ADDENDUM # 003

ST. CLAIR CATHOLIC DISTRICT SCHOOL BOARD MONSIGNOR UYEN CATHOLIC SCHOOL

TENDER NO.: 618-CP1510

Issue Date: Wednesday, May 6, 2015

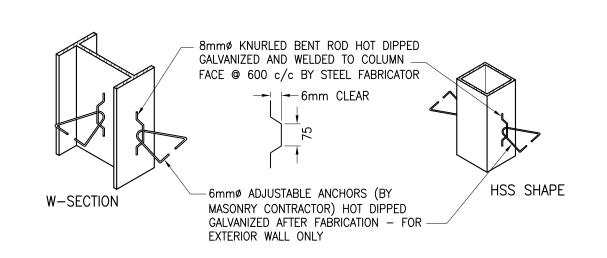
- 1. Shore existing W8x17 lintel to allow for removal of brick veneer and concrete block at lintel end support down to existing foundation wall. Provide new HSS 127x127x6.4 column + 175mm wide x 16mm thick x 280mm long baseplate anchored with 4-16mm diameter threaded rods drilled and epoxied minimum 150mm into existing block foundation wall. Column to extend to underside of existing W8x17 lintel. Provide welded connection from existing W8x17 lintel to new HSS column. Provide one L51x51x6.4mm diagonal brace (at approximately 45 degrees) from top of new HSS column to top chord of adjacent OWSJ. Provide masonry anchorage to steel column as per typical detail 4.05 on attached sketch SK-01 and rebuild concrete block and brick veneer.

- 2. Provide new 2-L89x89x6.4 back to back angle lintel for new window opening. Angles shall be welded at 400mm o/c top and bottom of lintel with first weld 75mm from ends of angles. Cut webs of concrete blocks around vertical legs of lintel. Connect new lintel to new HSS 127x127x6.4 column at one end, and bear minimum 200mm on concrete block wall at other end. Grout concrete block solid under lintel bearing.
